March 22, 2021

Town of Hingham
Planning Board
210 Central Street
Hingham, MA 02043
(Submitted Electronically via Email)

**RE: 100 Industrial Park Road – Amazon Last Mile Facility
Comments/Questions Regarding Special Permit A3 Parking Determination & Waiver**

Title: HUB ELEVATIONS AND CASEWORK DETAILS

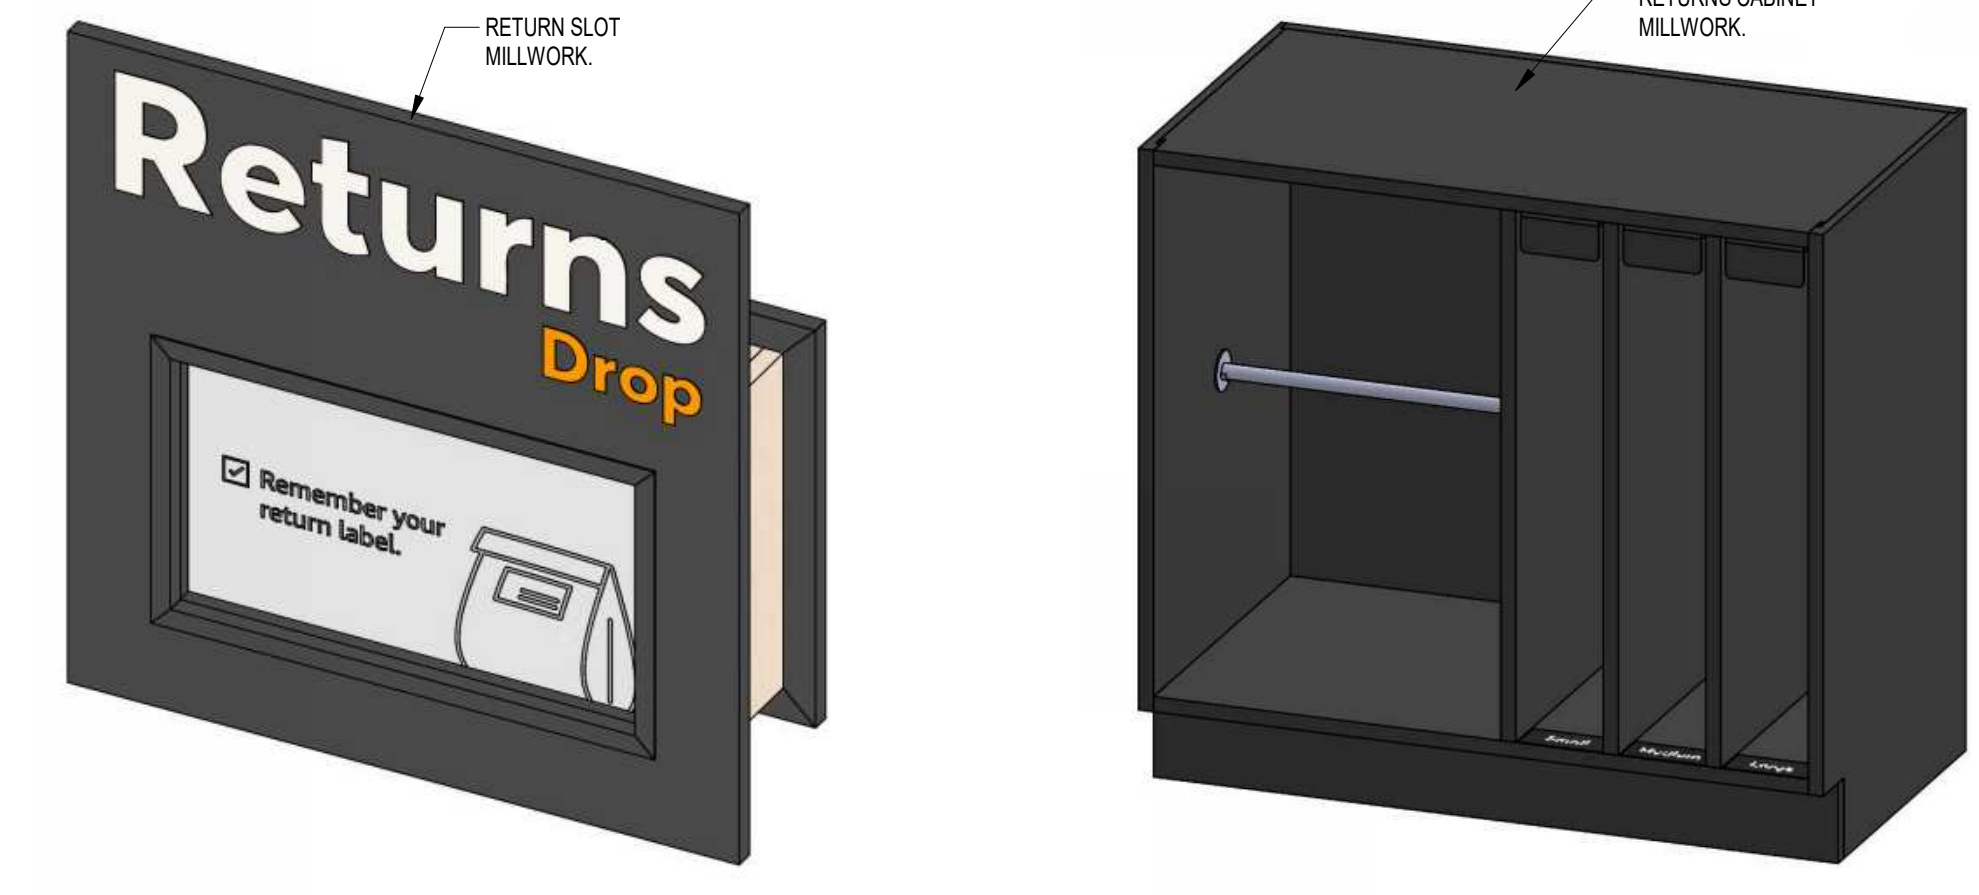
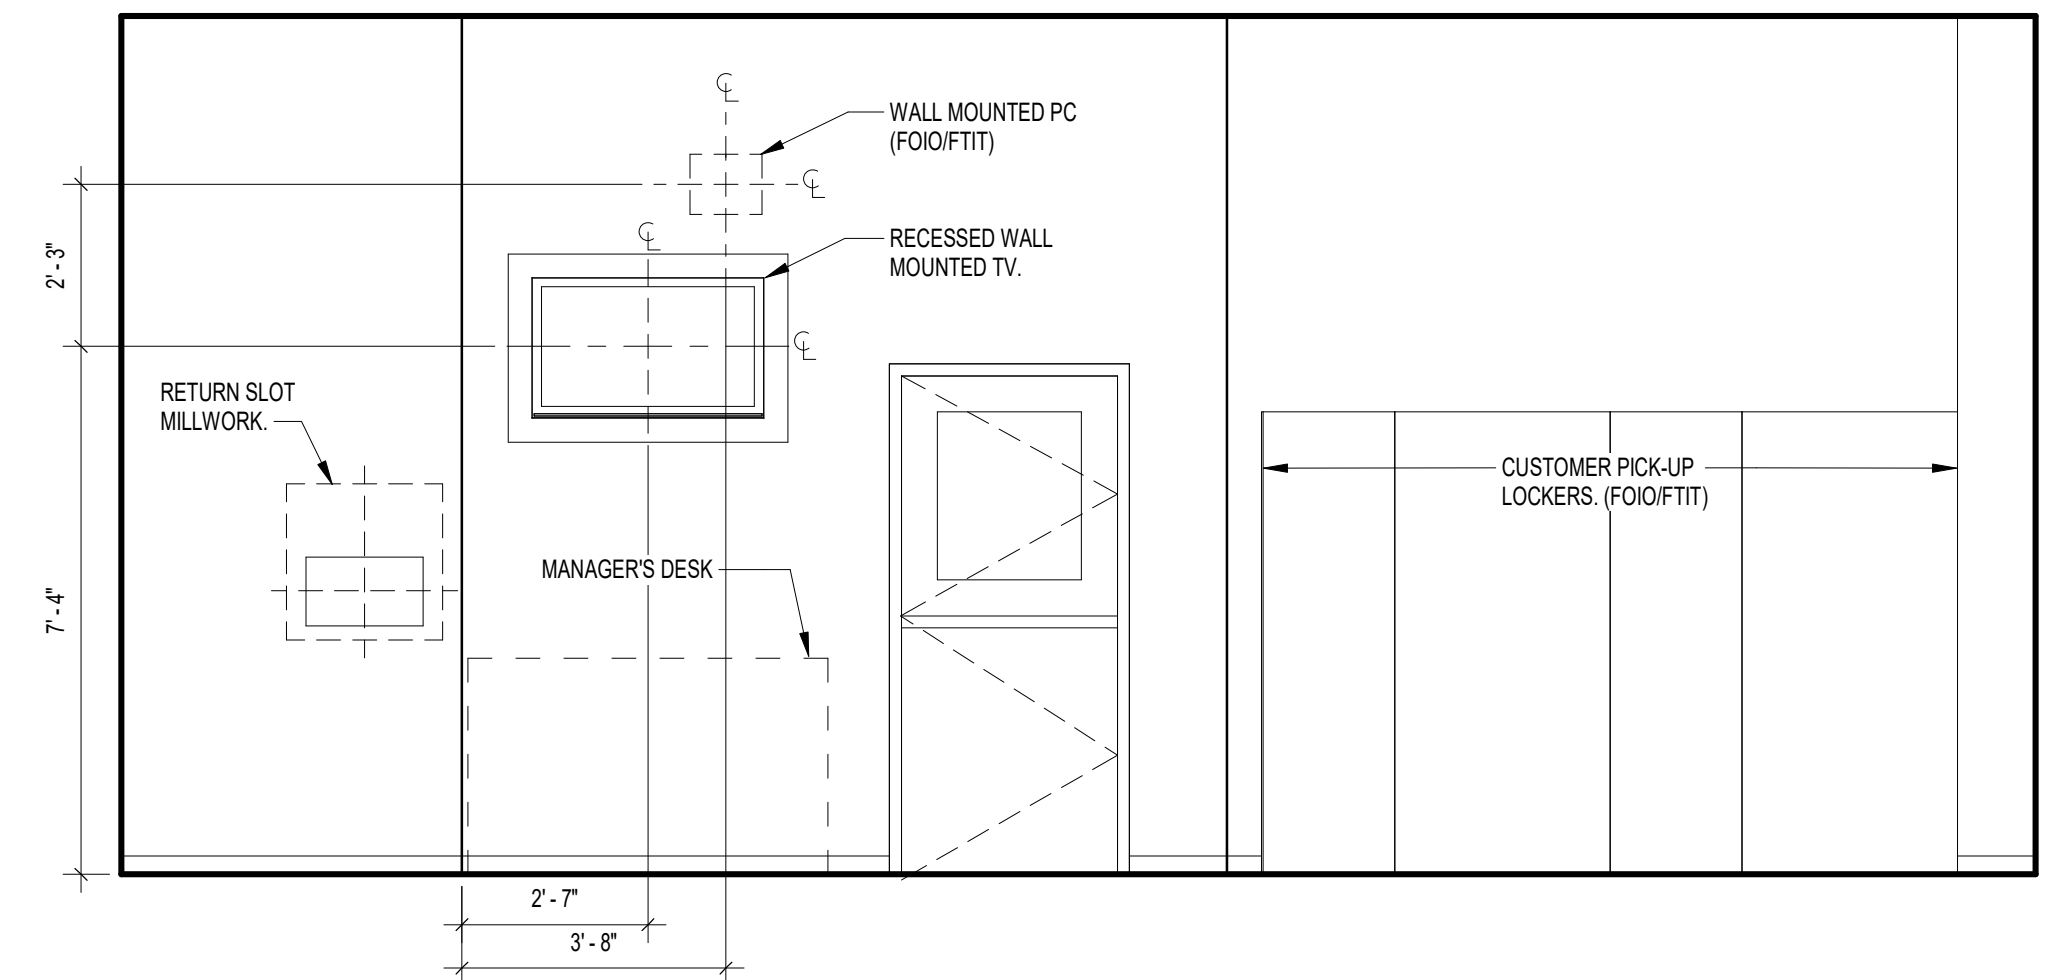
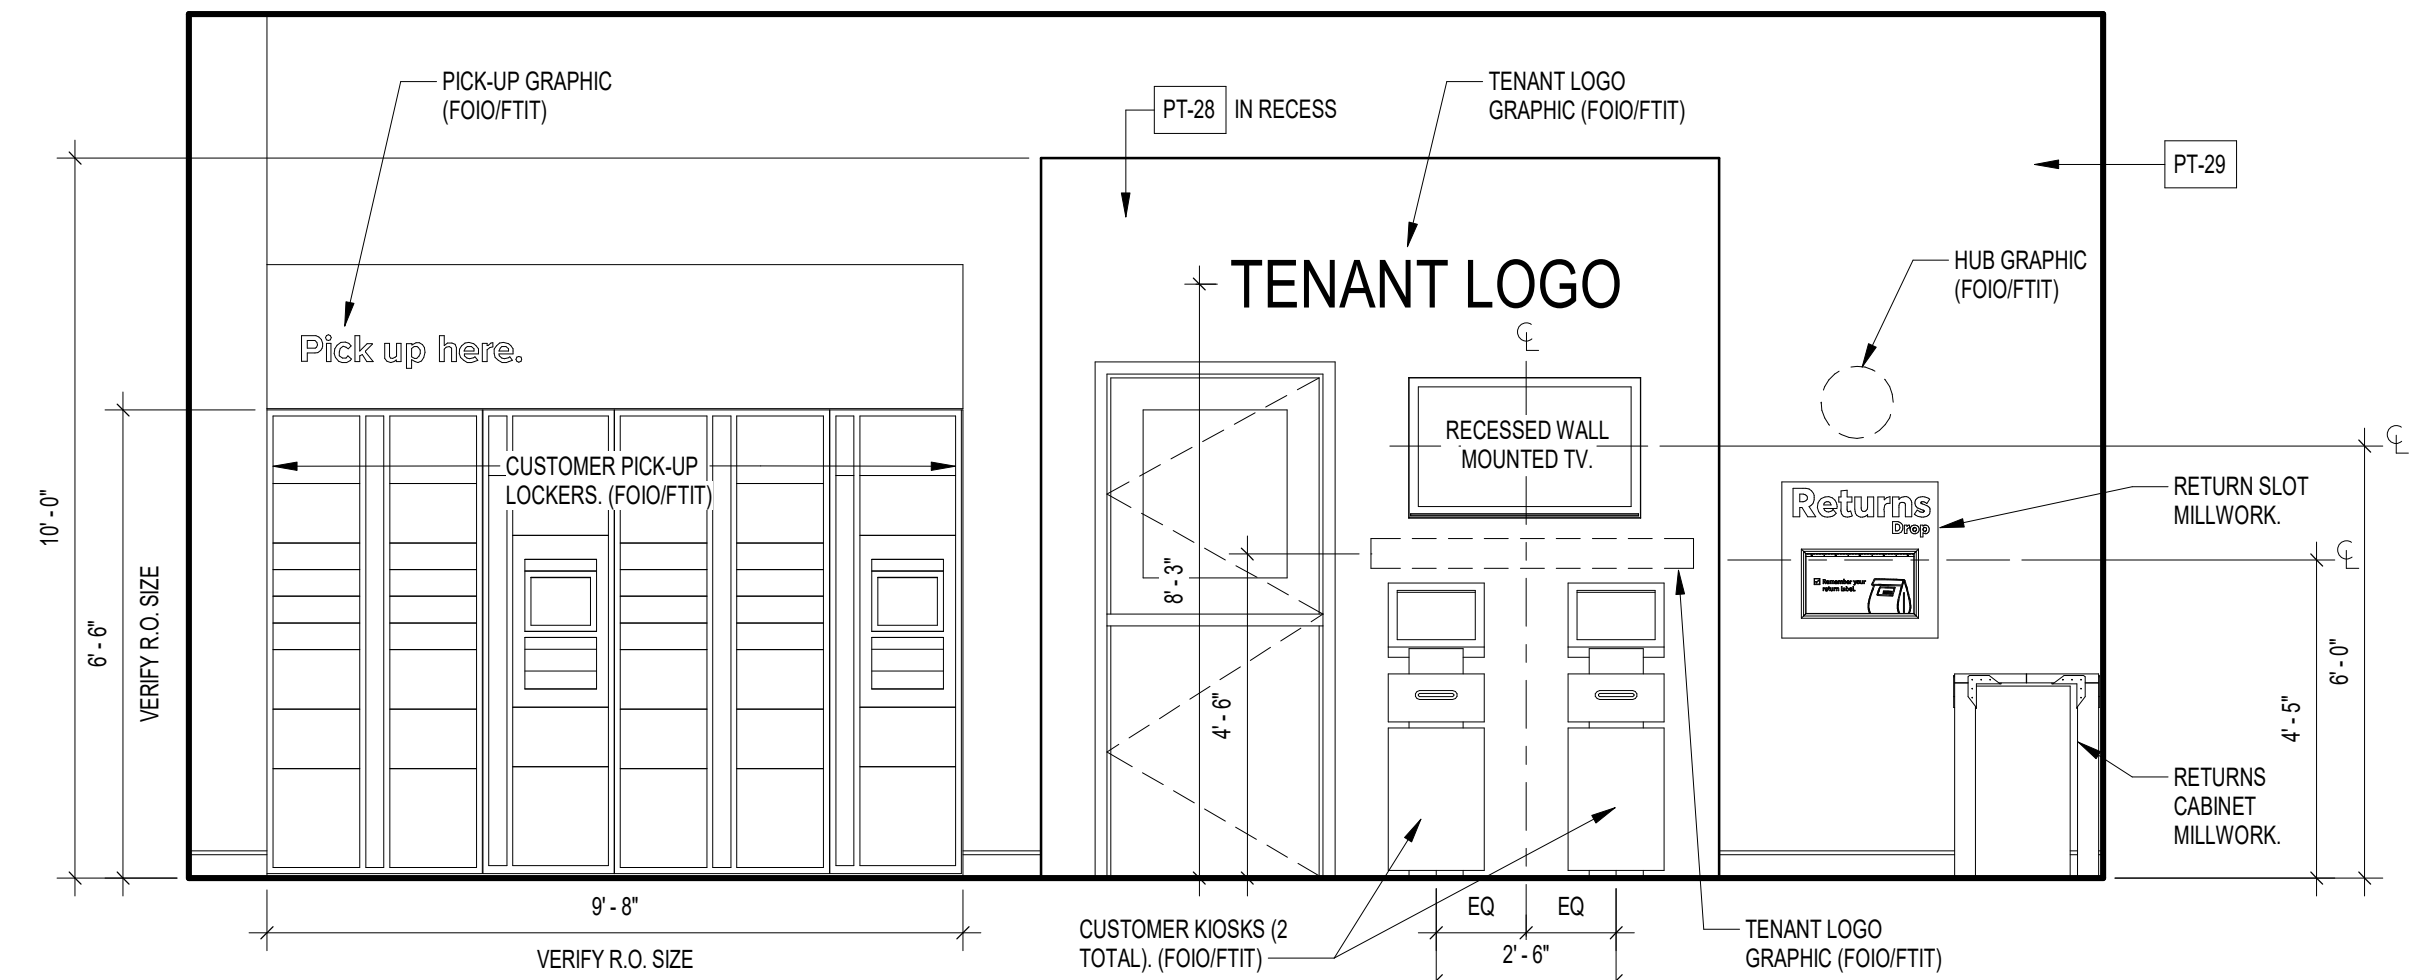
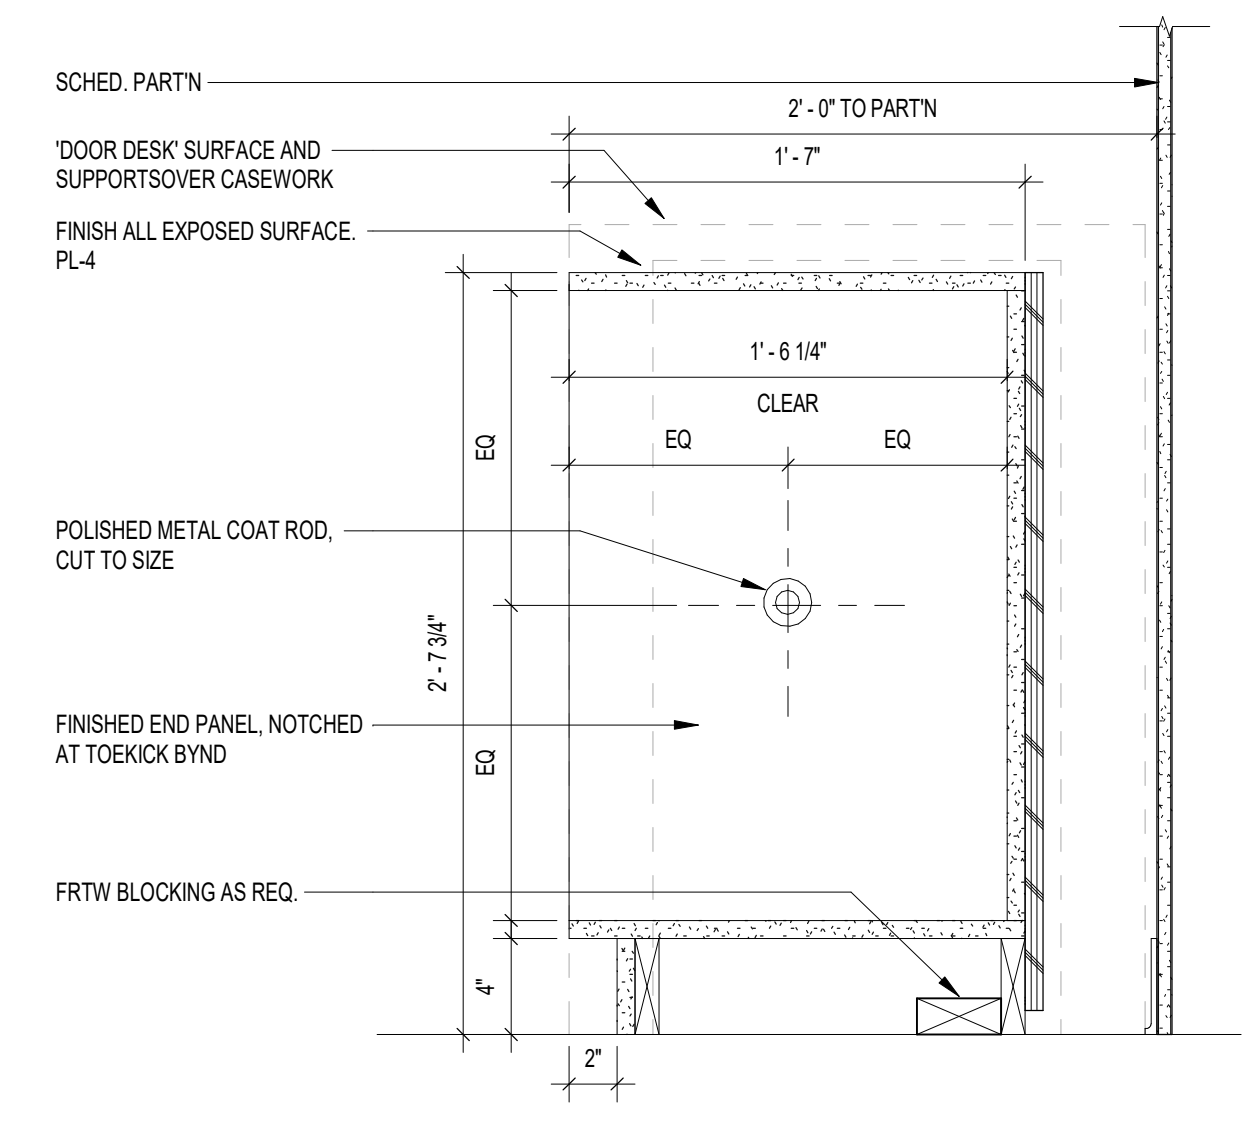
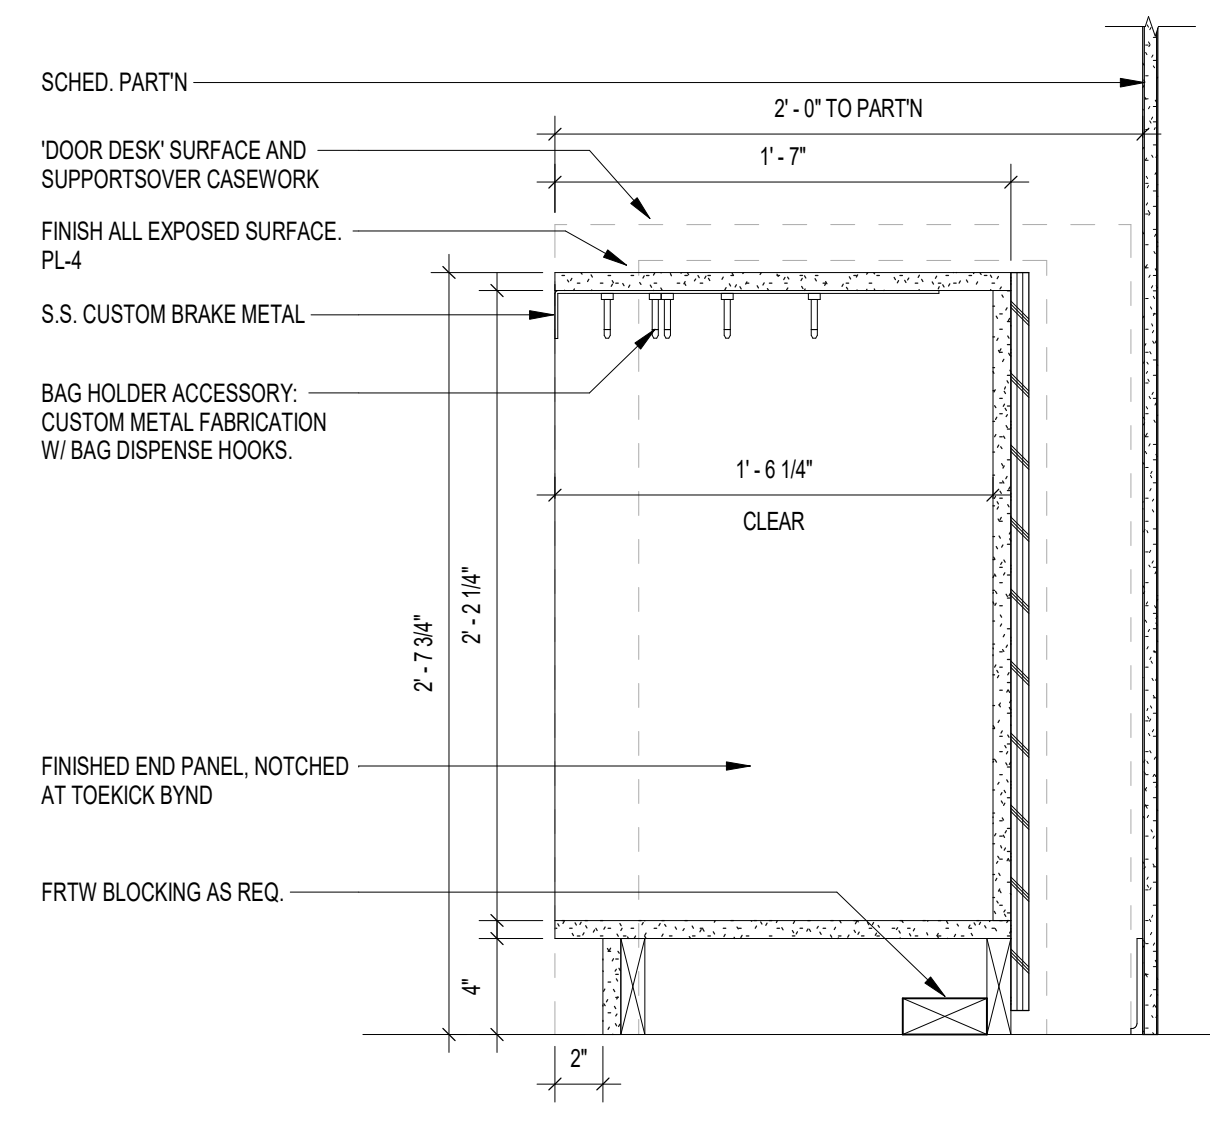
- See attached copies of sheets A1.02 and A11.03 (Attachment A) prepared by BL Companies that are on file with the Hingham Building Department as part of the pending Building Permit Application(s).
- The BL Companies Building Plans identify and detail a “Tenant Hub.” The detailed views of this hub clearly identify “Customer Kiosks” as well as “Customer Pickup Lockers” and package “Return Slots.”
- We ask what parking requirements have been determined for this public-facing element, where spaces have been provided and what provisions are provided for directional signage to direct the public accordingly?
- Why have no vehicle trips for this use been accounted for in the Supplemental Traffic Information report dated February, 2021?
